# 1984 Corvette: Service Bulletin: Side Door Lateral Movement

**Bulletin No:** 84-118, Section: 10 (I)

**Date:** April, 1984

FIGURE 1

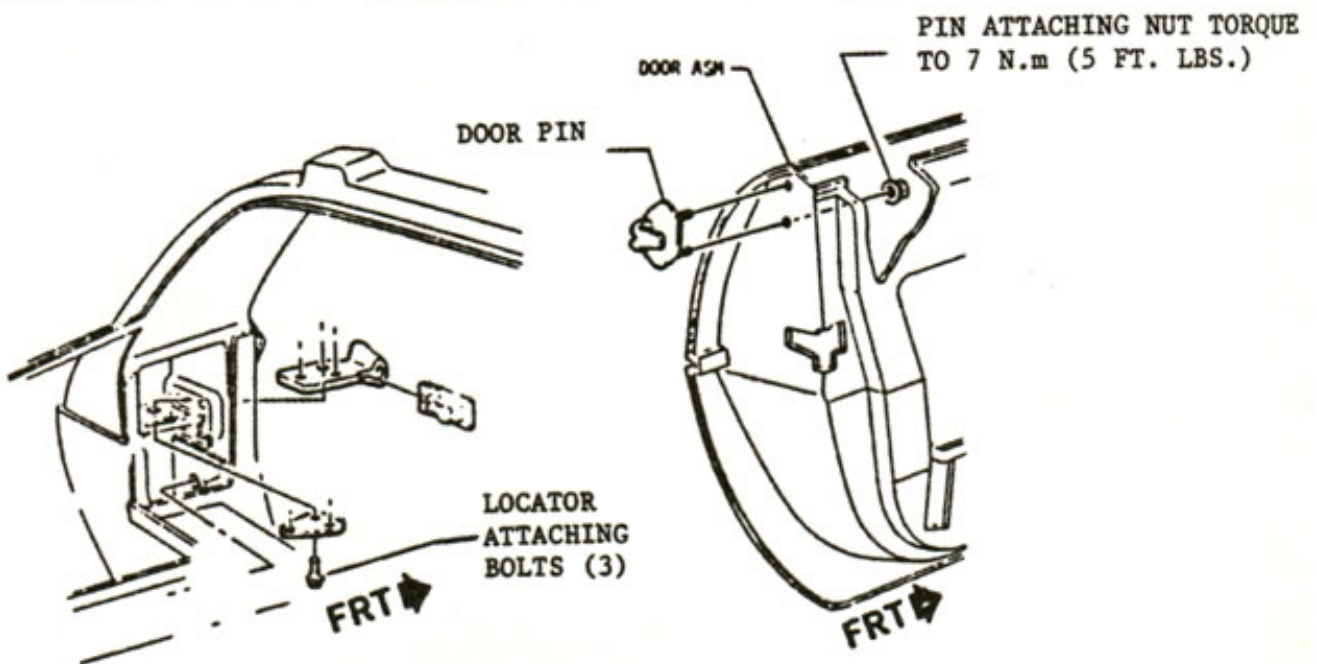
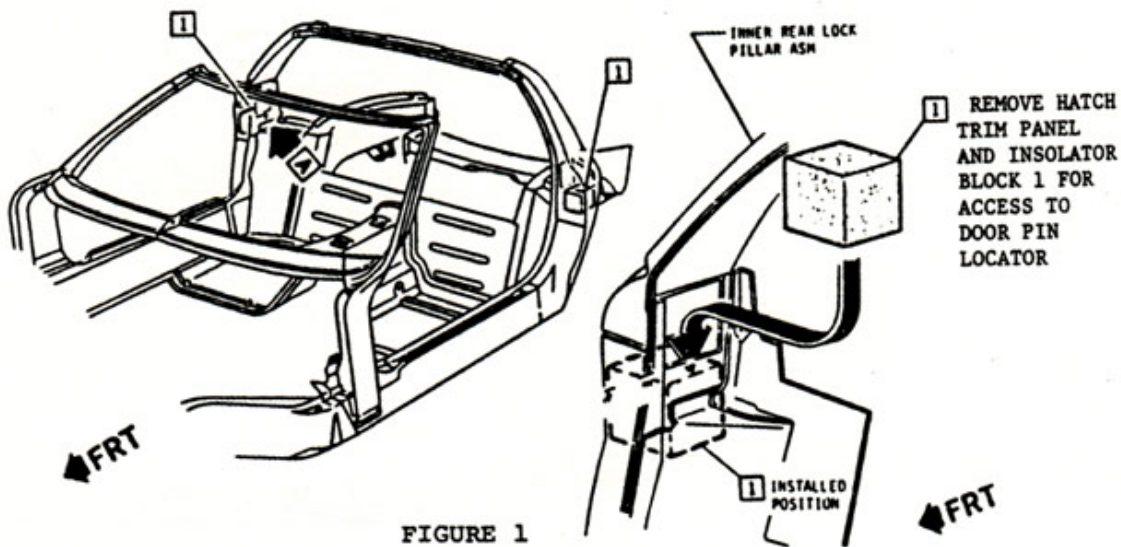
Verify the plastic sleeve is installed in the pin locator assembly. With the vehicle door closed, loosen the locator three (3) attaching bolts (see Figure 1). The locator assembly is to be centered fore-aft and vertically on the door pin. Push the locator outboard to fully engage the door pin and tighten the locator attaching bolts to 11 N.m (8 ft. lbs.)

FIGURE 2

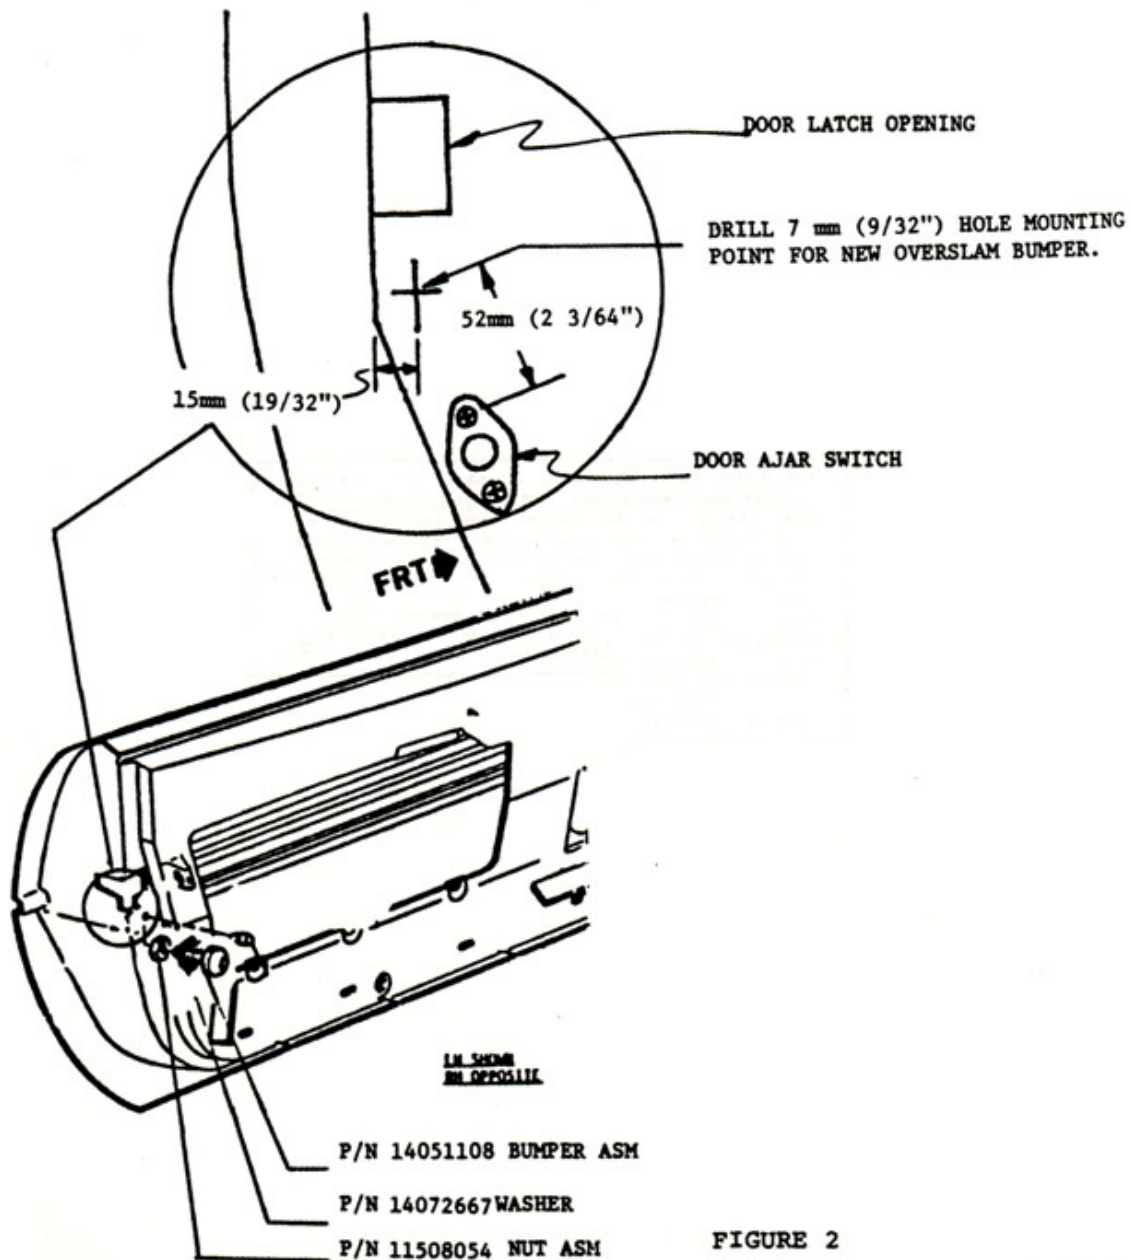
Some early built vehicles did not have overslam bumpers. If this is the case, it will be necessary to drill a 7mm (9/32") hole in the door (see Figure 2).

Add shims (washers) between bumper and door, as required, to eliminate lateral door movement (see Figure 2). DO NOT "OVERSHIM" BUMPER.

Replace the discarded production bumper(s) with bumper, P/N 14051108, attaching nut, P/N 11508276, and P/N 14072667, flat washers, which are to be used as bumper shims. The number of shims required will vary from vehicle to vehicle depending on "Build stacks".

Once shim pack has been established, tighten bumper retaining nut to 12 N.m (9 ft. lbs.) and check the door ajar lamp for proper operation. The door ajar switch is self-adjusting and cannot be reset.
